Staff Report

To: Salt Lake City Historic Landmark Commission
From: Carl Leith, Senior Planner
801 535 7758 or carl.leith@slcgov.com
Date: March 2, 2017
Re: PLNHLC2017-00052 New Construction

NEW CONSTRUCTION – APARTMENT BUILDING

PROPERTY ADDRESS: 480 SOUTH TEMPLE (Previously 454-466 South Temple)
PARCEL ID: Previously 1606202008 & 1606202009
HISTORIC DISTRICT: South Temple Local Historic District
ZONING DISTRICT: H Historic Preservation Overlay District. R-MU (Residential/Mixed Use District)
MASTER PLAN: Central Community Master Plan
DESIGN GUIDELINES: Historic Apartment & Multi-Family Design Guidelines

ISSUE 1: Context Height & Scale

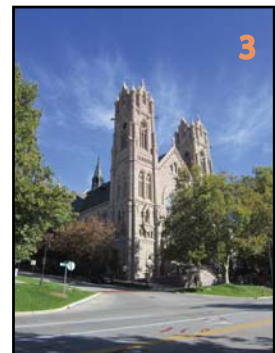
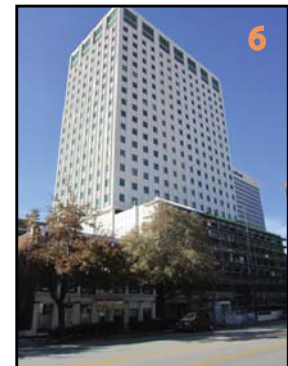
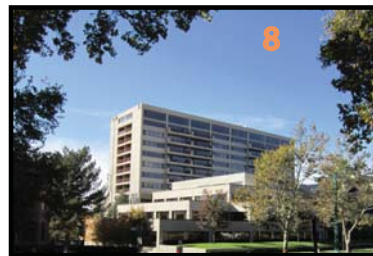
Issue 1: PROPOSED HEIGHT, SCALE & MASSING OF THE DEVELOPMENT & THE SETTING OF THE PICCADILLY APARTMENTS ON 500 EAST Att.H: Stds. 1.a & 1.d See Recommendation Conditions

The proposed height of the building would be six floors to South Temple, rising to seven floors progressing towards the south façade across the falling ground level on the site. The latter then steps down to six floors approximately 20 feet short of the south façade. Proposed height along South Temple is high in the context of the general 1 to 3.5 story scale of this part of the South Temple Historic District. In the broader setting of South Temple the height as proposed falls more readily within the scale of the taller buildings along the street. Setting the central range of the façade back from the street frontage creates a more characteristic apartment form, massing and scale. The deeper central courtyard to the rear creates a variant on the traditional “H” plan form of a traditional apartment building – an effective configuration, modulation and massing to reduce the scale of a much larger building. Additional design attention to enhance the stature and design of the ground floor of the building, coupled with design variation to differentiate the top floor, would help to temper the apparent height and scale of the proposal. See Issue 3 below.

The height of the proposed façade to 500 East, although demonstrating some articulation rather than modulation, is accentuated by the decline as the street falls away to the south. This becomes problematic in the setting of the Piccadilly Apartment building to the immediate south with the proposal approaching the latter building with seven and then six floors. Although the proposed development would step down as it approaches the Piccadilly it still rises abruptly two floors to its immediate north, prior to rising an additional floor. The current proposal would be over-dominant in height and massing, and would be more visually compatible if it stepped down a further floor at that point, or stepped down in two stages towards the Piccadilly Apartments.

Recommendation: Staff would recommend that the proposal is revised to achieve a more compatible relationship as discussed above.
